STAFF REPORT

CITY OF COLUMBUS PLAN COMMISSION
(March 12, 2014 Meeting)

Docket No. / Project Title:	MP-14-01 (Berean Bible Church 3rd Replat)
Staff:	Thom Weintraut
Applicant:	The Ridge of Columbus, Indiana, Inc
Property Size:	3.20 Acres
Current Zoning:	RS3 (Residential: Single-Family 3)
Location:	51 N. Brooks Street, in the City of Columbus

Berean Bible Church 3rd Replat

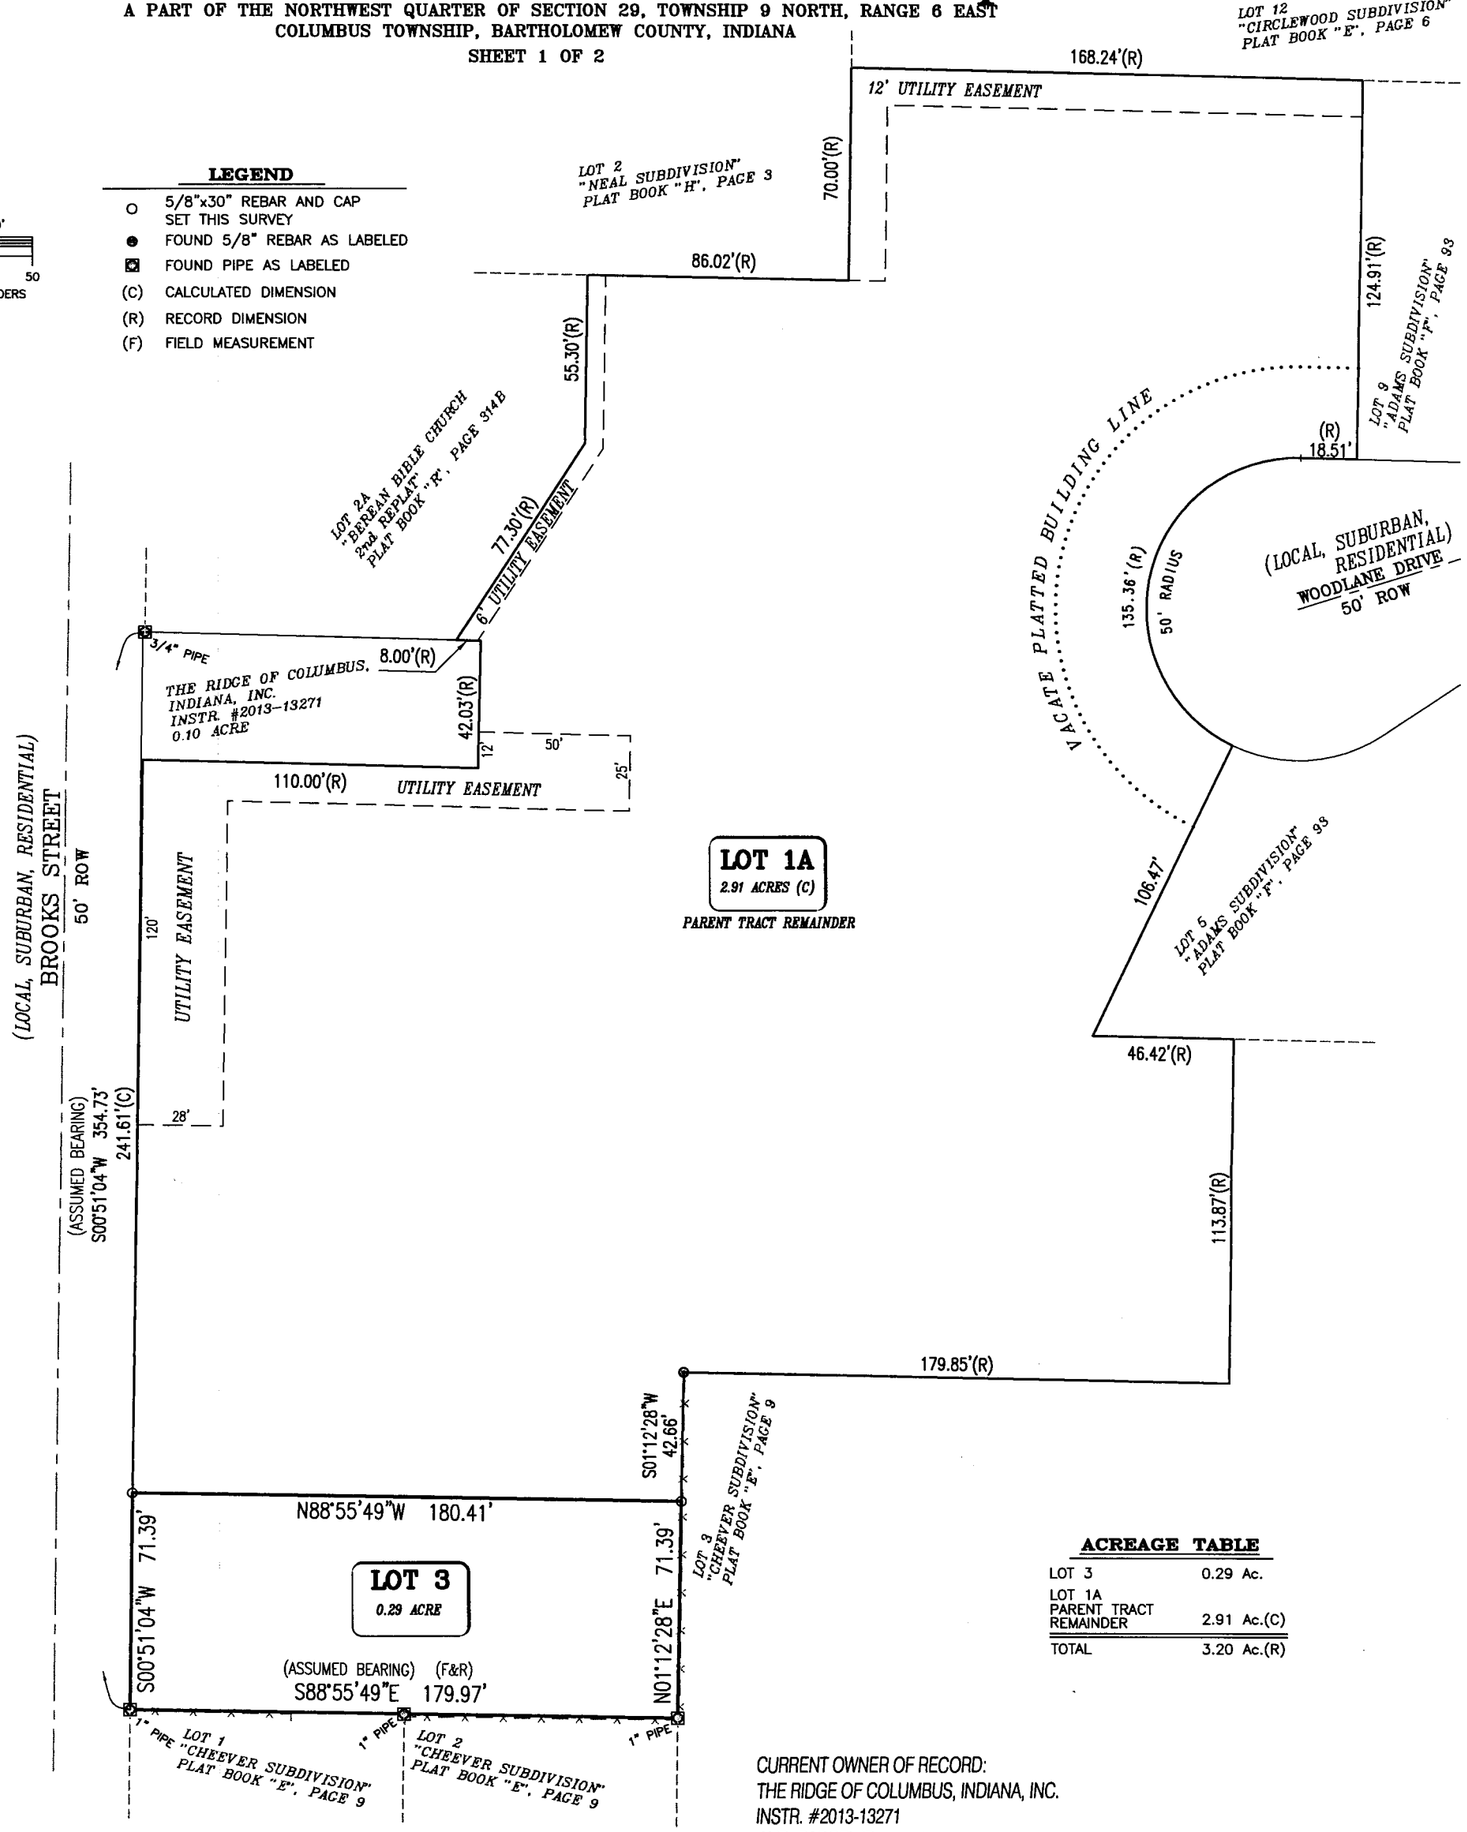
Key Issue Summary:
The following key issue(s) should be resolved through the consideration of this application: Should a sidewalk be installed along the frontage of the new lot, Lot 3, as required by Section 16.24.010(B) of the Subdivision Control Ordinance.

The following outstanding technical comments must be addressed by the applicant: The applicant shall resolve the driveway setback issue before the plat can be recorded.

Interdepartmental Review:	
City Engineering:	Sidewalks should be installed along the frontage of the new lot since it is in close proximity to the Indiana Avenue project where pedestrian access is a priority.
City Utilities:	No comments provided.
Parks Department:	No comments provided.
MPO:	No comments provided.

2. The existing driveway for Lot 3 has access from the parking lot of the church and would not meet the side setback requirements of Section 7.2(B)(2) of the Zoning Ordinance if the new lot were created. The applicant has stated they will be constructing a new driveway from Brooks Street and removing the existing driveway that connects to the church parking lot.

3. The new lot, Lot 3, is approximately 135 feet north of Indiana Avenue and there are currently no sidewalks between this property and Indiana Avenue. The Indiana Avenue improvement project is currently underway with construction likely to begin later this year. As part of that project, sidewalks will be installed/replaced along both sides of Indiana Avenue from State Street to Marr Road. Brooks Street south of Indiana Avenue has a continuous sidewalk on the east side of Brooks Street providing a connection between State Street and Indiana Avenue.

Preliminary Staff Recommendation:
Approval of the Subdivision, including the request of a modification from Section 16.24.010(B) of the Subdivision Control Ordinance for relief from the requirement of installing sidewalks along the frontage of the new lot, Lot 3. Approval should be subject to the resolution of the outstanding technical comment.
